AMENDMENT OF SOLICITATION/MODIFICATION OF CONTRACT				1. CONTRACT ID CODE <div style="text-align: center;">J</div>		PAGE OF PAGES <div style="text-align: center;">1 2</div>

8. NAME AND ADDRESS OF CONTRACTOR (No., Street, County, State and Zip Code)				X		9A. AMENDMENT OF SOLICITATION NO. W9128F23Q0079	
				X		9B. DATED (SEE ITEM 11) 28-Jul-2023	
						10A. MOD. OF CONTRACT/ORDER NO.	
						10B. DATED (SEE ITEM 13)	
CODE		FACILITY CODE

14. DESCRIPTION OF AMENDMENT/MODIFICATION (Organized by UCF section headings, including solicitation/contract subject matter where feasible.) The purpose of this amendment is to provide the following information. 1. Question and answer added. 2. Reference drawing added. All other terms and conditions remain unchanged.							
Except as provided herein, all terms and conditions of the document referenced in Item 9A or 10A, as heretofore changed, remains unchanged and in full force and effect.							
15A. NAME AND TITLE OF SIGNER (Type or print)				16A. NAME AND TITLE OF CONTRACTING OFFICER (Type or print)			
				TEL: _____ EMAIL: _____			
15B. CONTRACTOR/OFFEROR _____ (Signature of person authorized to sign)		15C. DATE SIGNED		16B. UNITED STATES OF AM

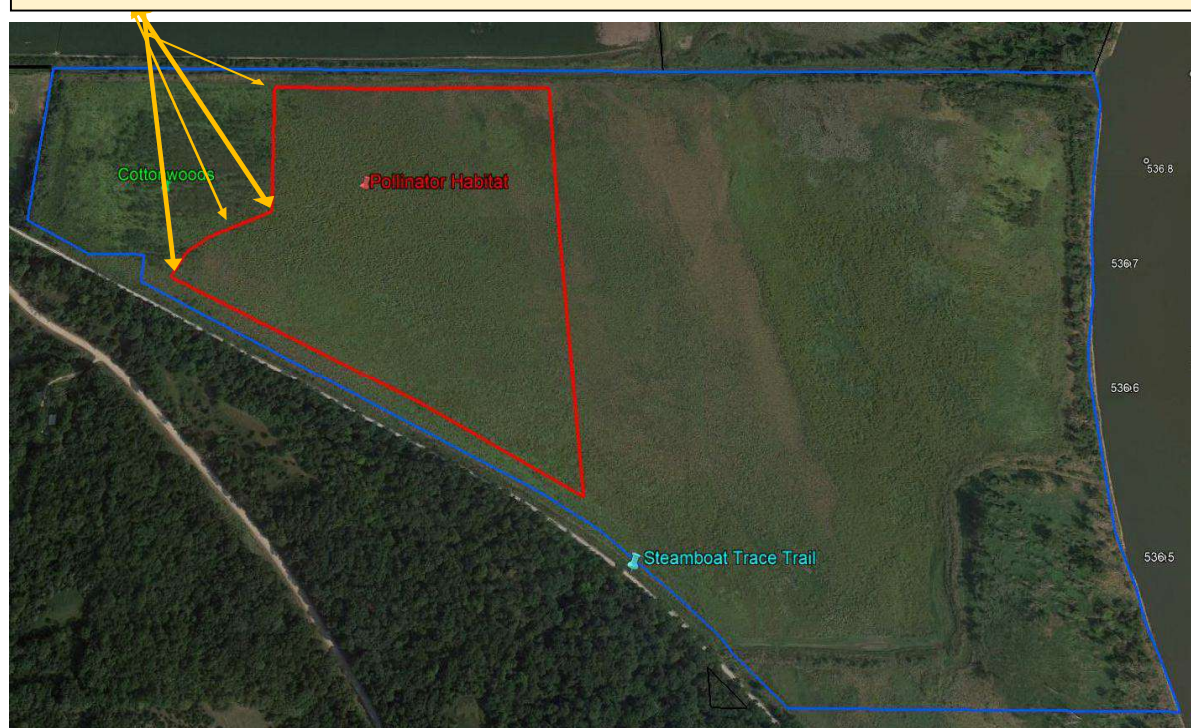
Question: We checked the site and even though it is mostly flat, some trees are still present. Are the trees being kept intact for the project or they will need to be cut and removed?

Answer: The larger community of cottonwood saplings that are establishing in the west portion of the site are to REMAIN. However, there will be some small diameter cottonwood saplings that are just outside the perimeter to the east of the larger cottonwood community that will need to be mowed/removed so that there is a clear line/buffer between the larger cottonwood community and the pollinator habitat.

Remove any small cottonwood saplings that are edging outside of the larger cottonwood community towards the east and would be encroaching on the pollinator habitat.
